Access Compliance Report Public Rights-of-Way (Curb Ramps)

Main Street: SHADBURN_AVE Cross Street: MCCORMACK_LN Location: SE

ADA ID: RPRK210917162128 Ramp Type: Type 1 - Perpendicular Diagonal Initial Pass/Fail: Fail Overall Compliance: No Severity Score: 2

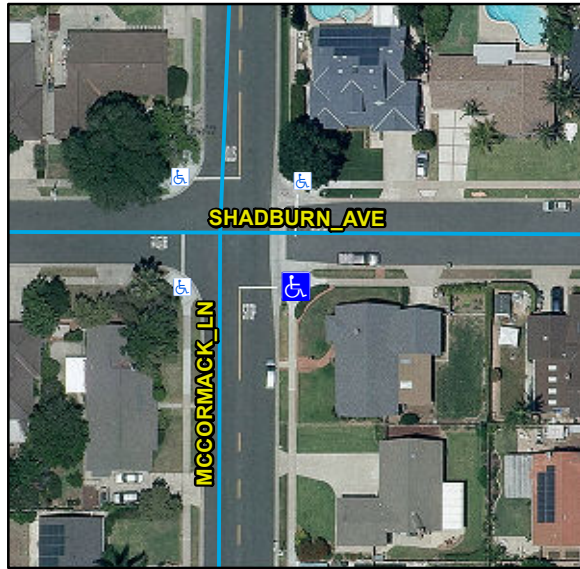
R304.2.2, R304.5.3, STD 1115

Remove & Replace Curb Ramp With Two New Directional Ramps or Equivalent.
